Subject: Duke Energy Corporation  
Catawba Nuclear Station, Units 1 and 2  
Docket Numbers 50-413 and 50-414  
Proposed Technical Specifications (TS) Amendment  
TS 3.4.3 - Reactor Coolant System (RCS) Pressure and  
Temperature (P/T) Limits  
TS 3.4.6, RCS Loops - MODE 4  
TS 3.4.7, RCS Loops - MODE 5, Loops Filled  
TS 3.4.10, Pressurizer Safety Valves  
TS 3.4.11, Pressurizer Power Operated Relief Valves  
(PORVs)  
TS 3.4.12, Low Temperature Overpressure Protection  
(LTOP) System

Pursuant to 10 CFR 50.90, Duke Energy Corporation is requesting an amendment to the Catawba Nuclear Station Facility Operating License and Technical Specifications (TS). The proposed amendment revises TS 3.4.3 to update the heatup, cooldown, critically, and inservice test pressure and temperature (P/T) limits for the reactor coolant system (RCS) of each unit to a maximum of 34 Effective Full Power Years (EFPY). The current P/T limits are valid to 15 EFPY. Based on current projected operating cycles the existing P/T limits are expected to expire in March 2004 for Unit 1 and November 2005 for Unit 2. The changes to TS 3.4.3 are based on the analyses of latest reactor vessel capsule data and alternative

Figure 3.4.3-1  
(UNIT 1 ONLY)  
RCS Heatup Limitations

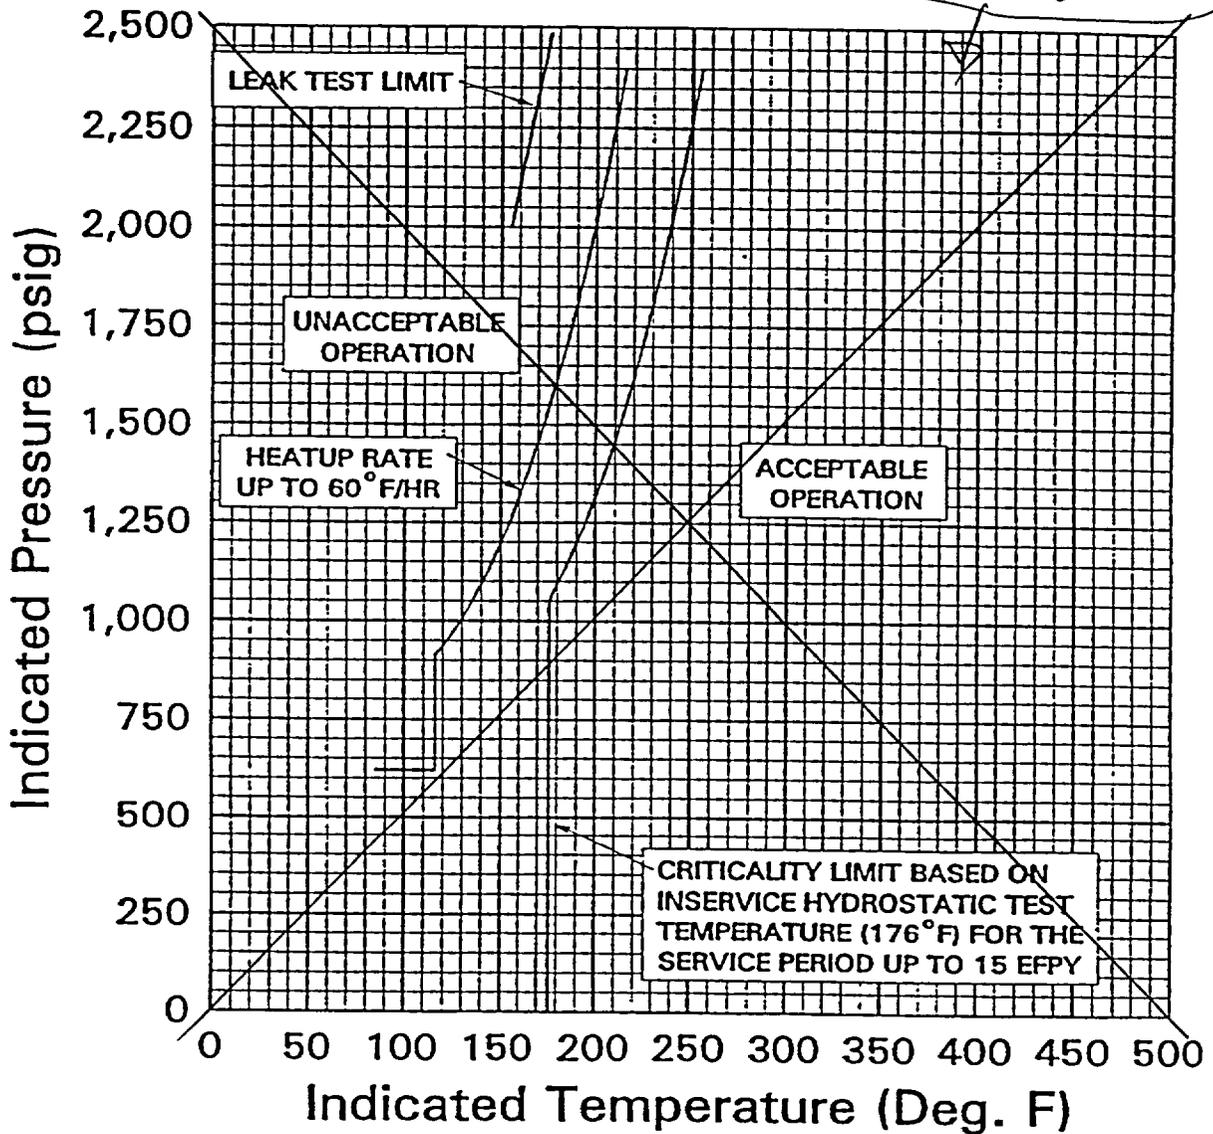
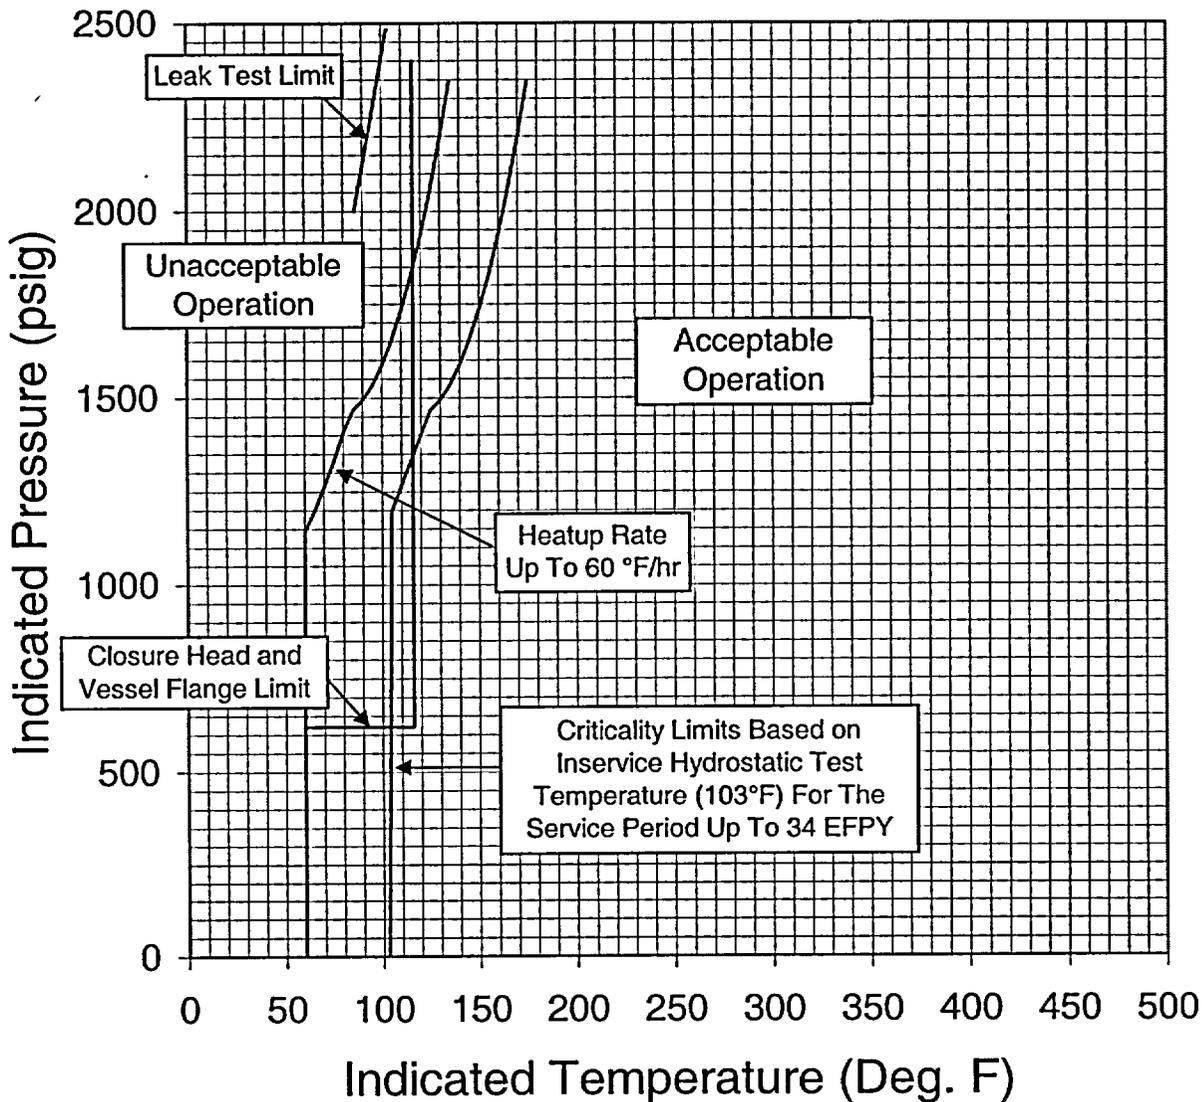
LIMITING ART AT 15 EPFY: 1/4-T, 43°F (42)  
34 3/4-T, 26°F (31)

*Insert  
New  
Chart A*

Limiting Material: Lower Shell Forging 04  
and Intermediate Shell Forging 05

Limiting ART at 34 EFPY: 1/4-T, 42°F  
3/4-T, 31°F

Figure 3.4.3-1  
(UNIT 2 ONLY)  
RCS Heatup Limitations

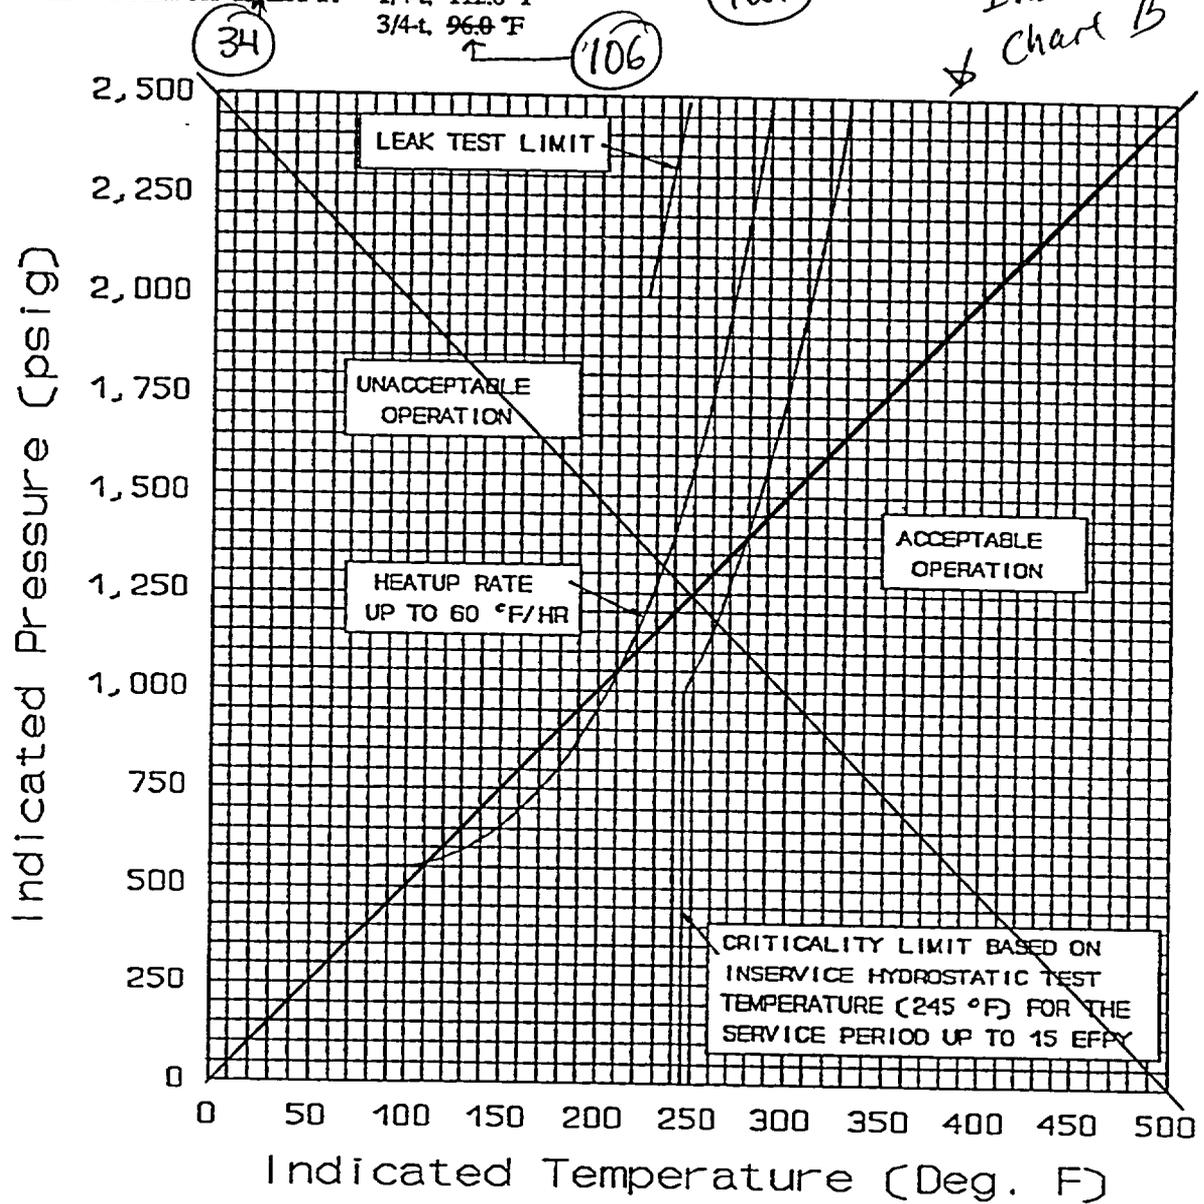
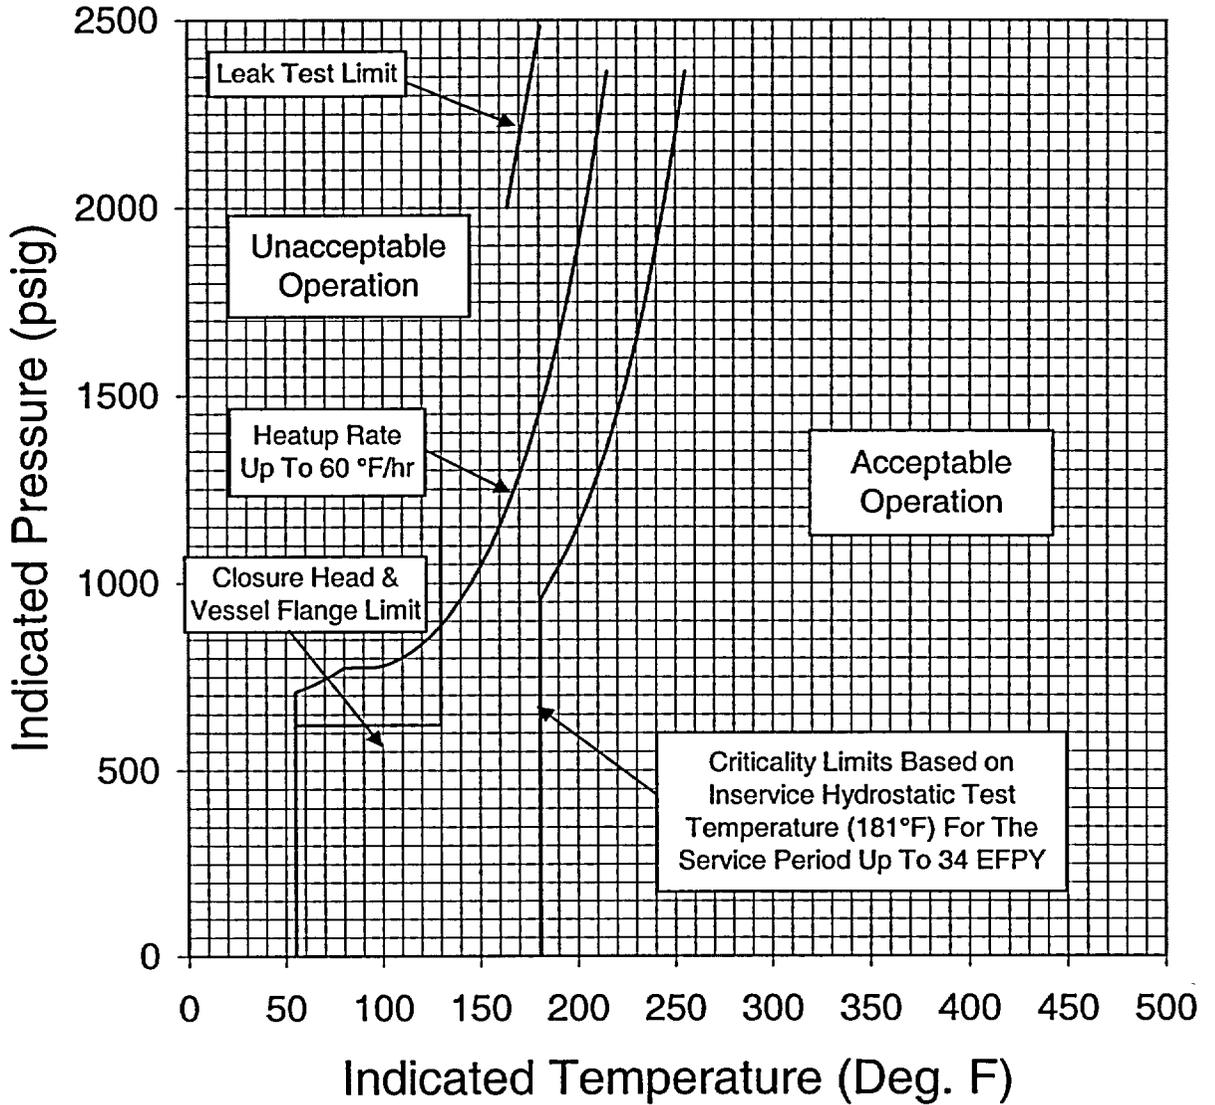
*Insert New  
Chart B*

Limiting ART at 34 EFPY: 1/4-T, 121°F

3/4-T, 106°F

Figure 3.4.3-2  
(UNIT 1 ONLY)  
RCS Cooldown Limitations

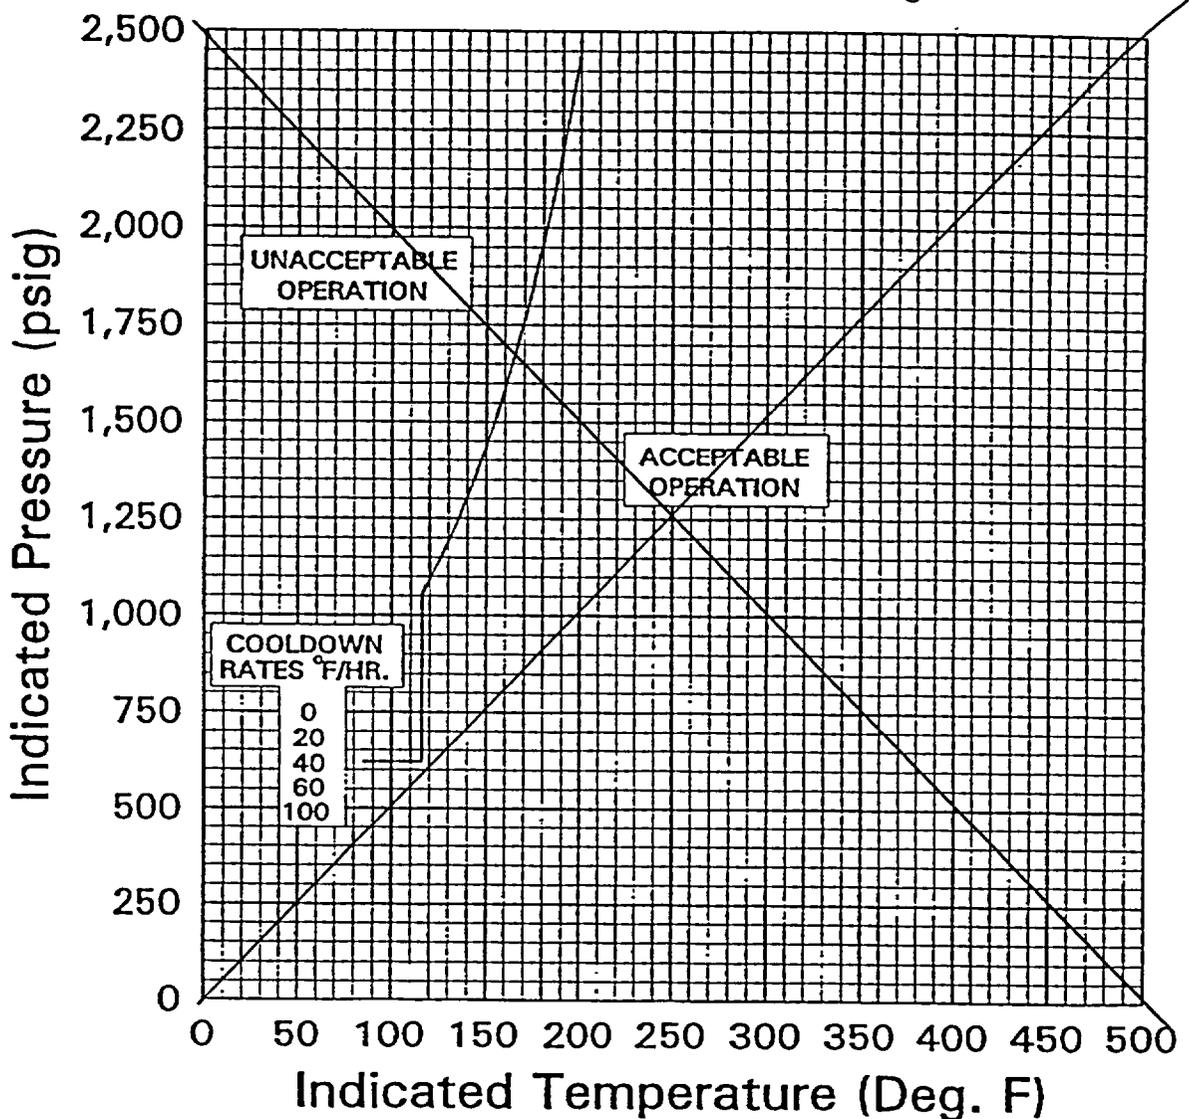
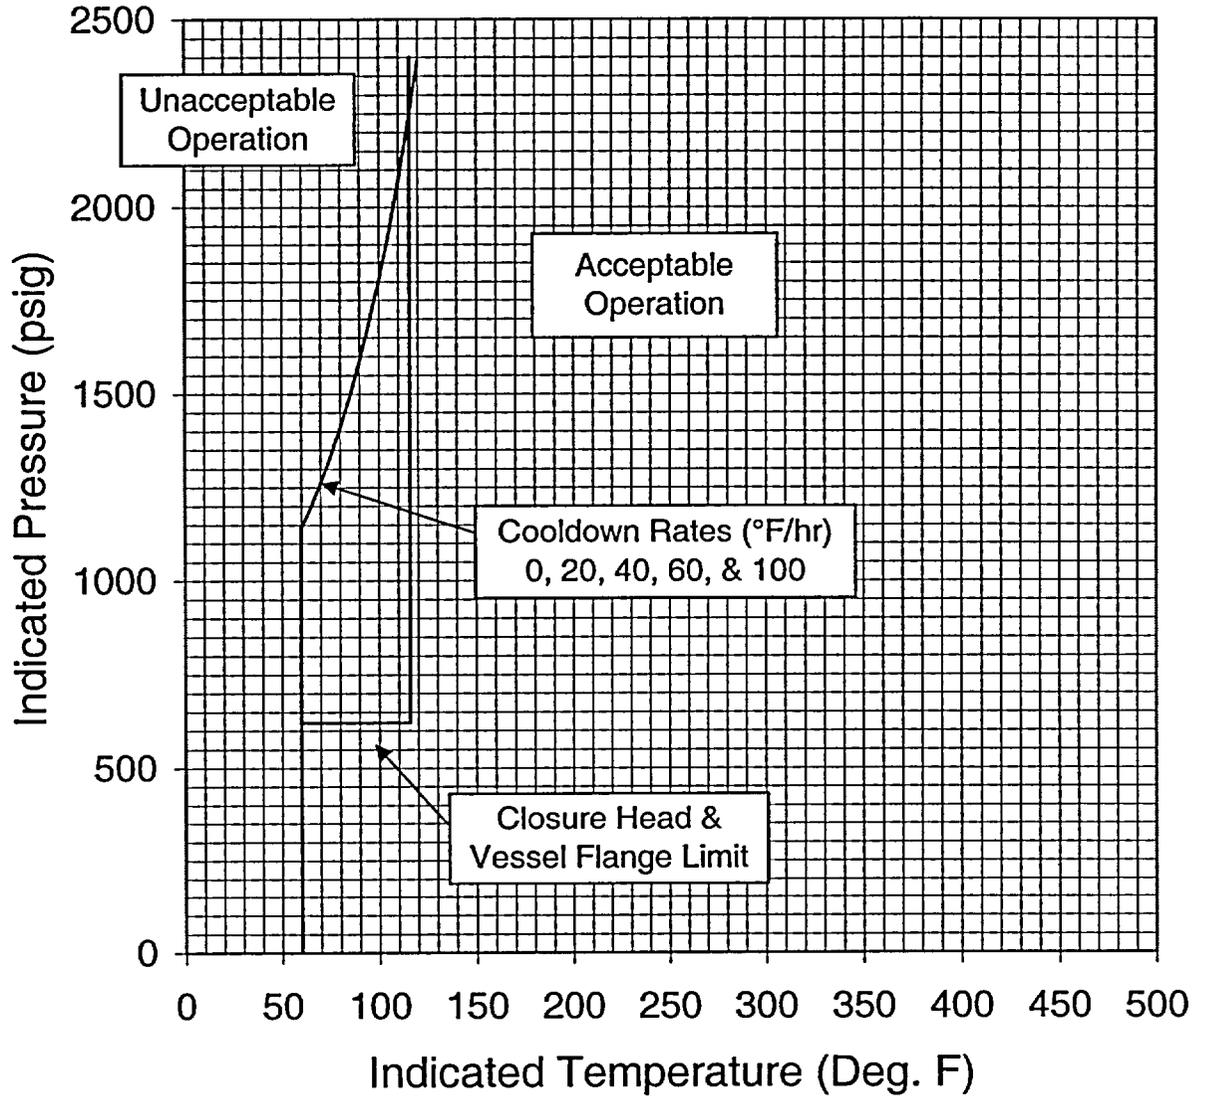
LIMITING MATERIAL: LOWER SHELL FORGING 04 05  $\frac{1}{2}$  04  
 LIMITING ART AT 15 EPFY: 1/4-T, 43°F (42)  
 34 3/4-T, 26°F (31)

*Insert New Chart C*

Limiting Material: Lower Shell Forging 04  
and Intermediate Shell Forging 05

Limiting ART at 34 EFPY: 1/4-T, 42°F  
3/4-T, 31°F

Figure 3.4.3-2  
(UNIT 2 ONLY)  
RCS Cooldown Limitations

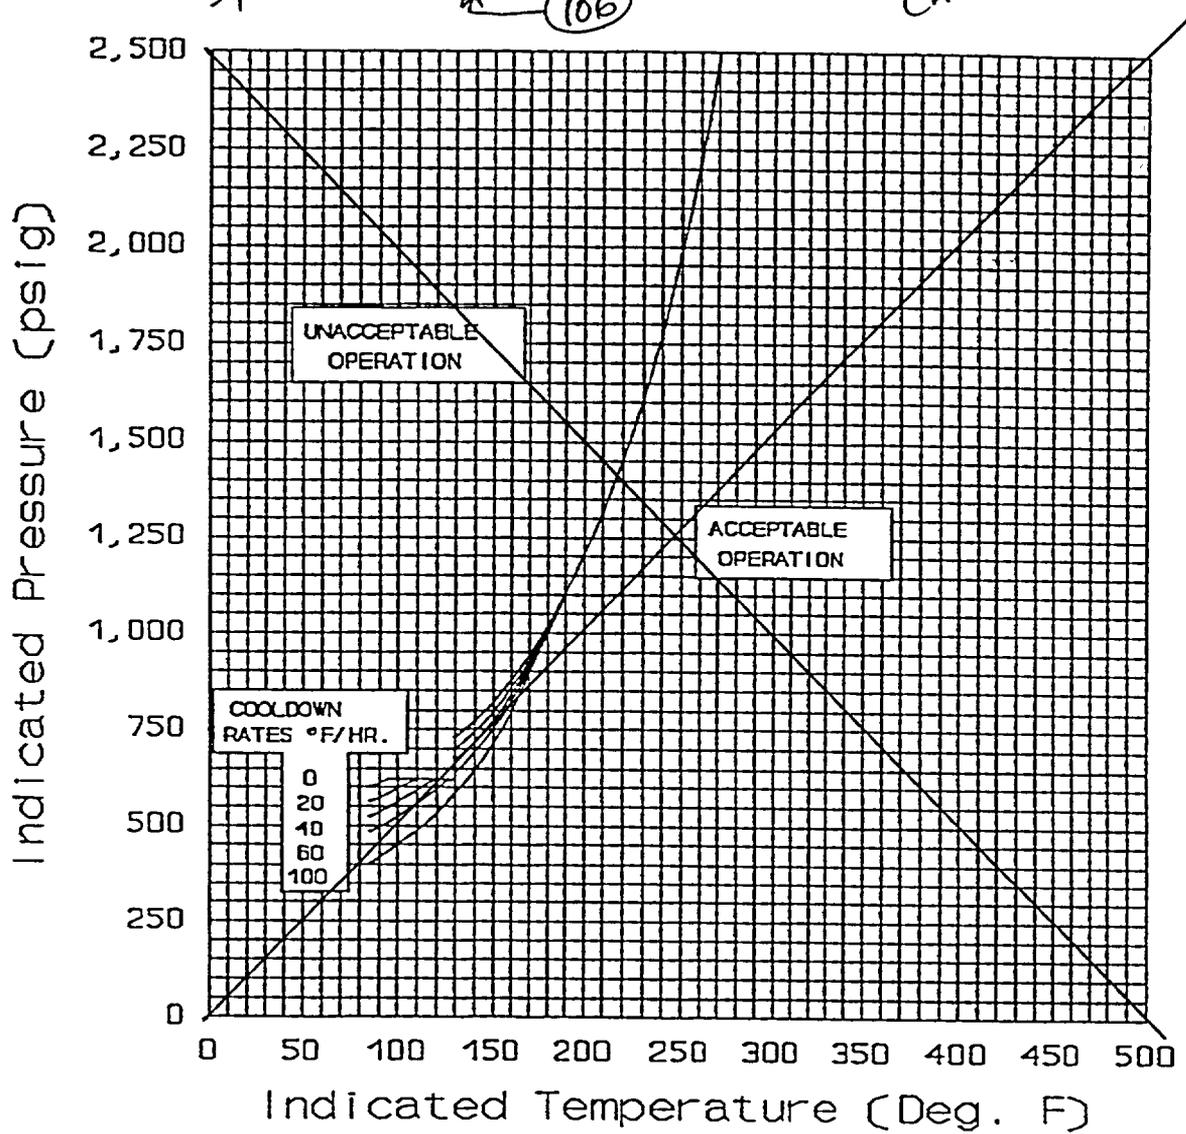
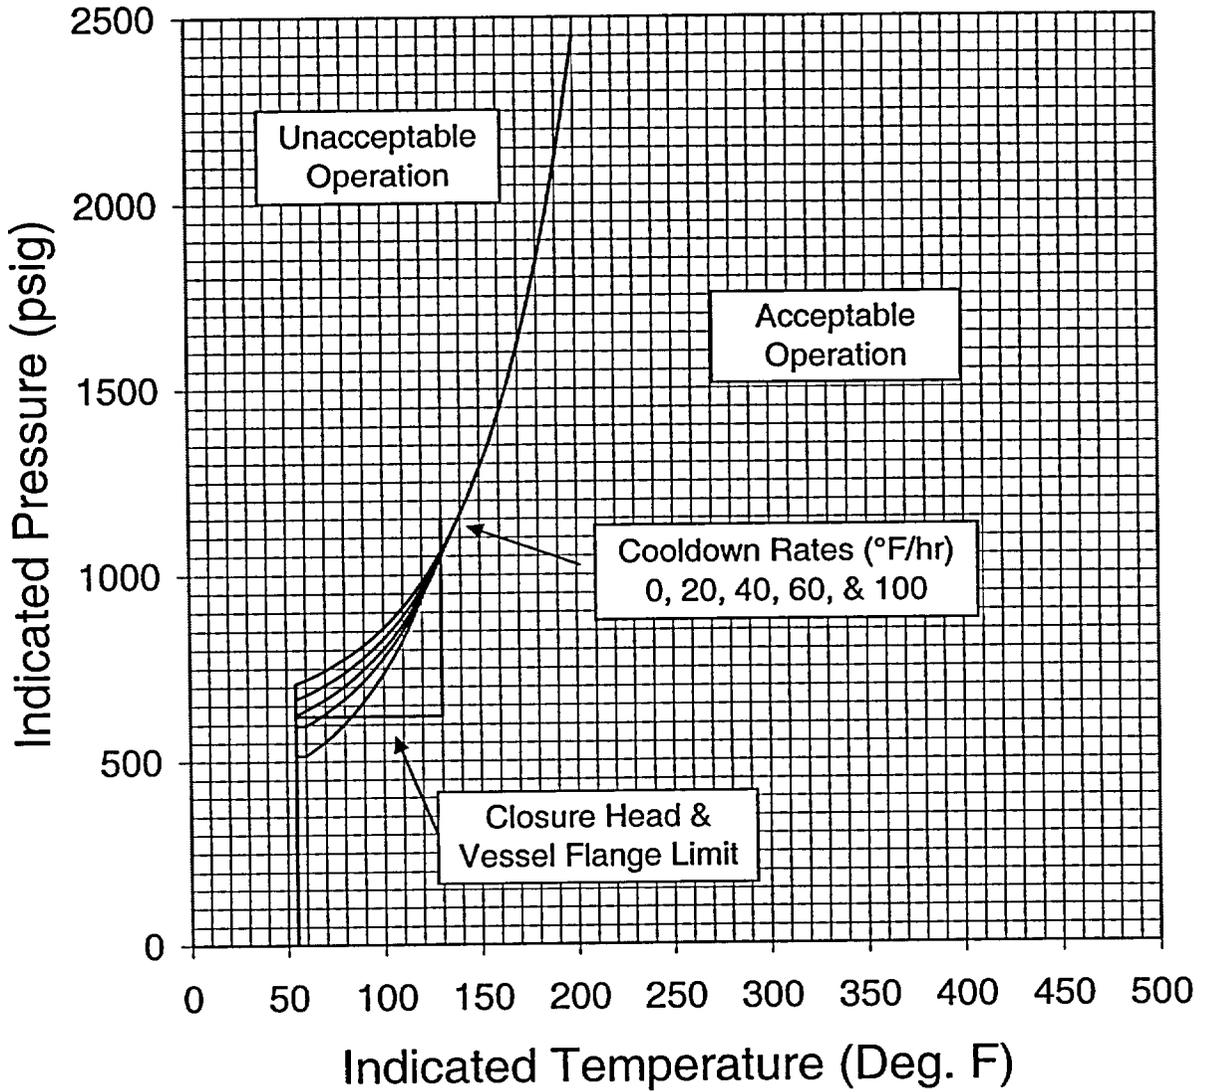
*Insert New Chart D*

Limiting Material: Intermediate Shell, B8605-2

Limiting ART at 34 EFPY: 1/4-T, 121°F  
3/4-T, 106°F
